CHANGE 3

**CHANGE 4**

Page 8-35, Figure 8-14 (Sheet 2 of 2).

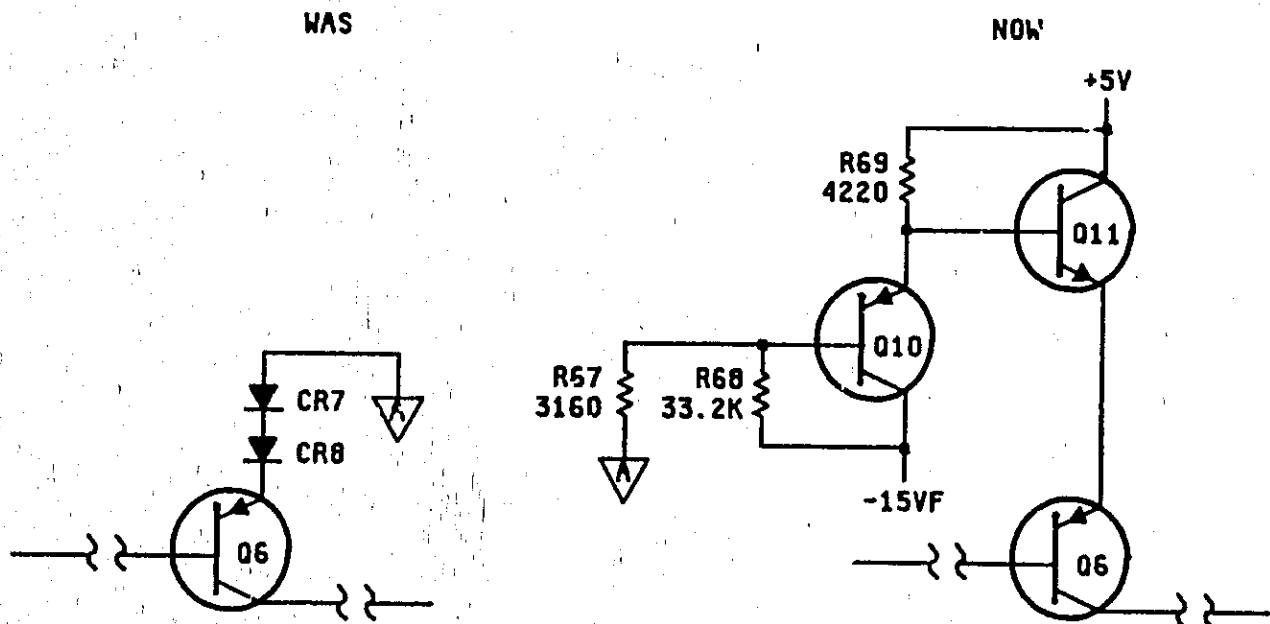
Make changes to A18Q6 emitter circuitry as shown below
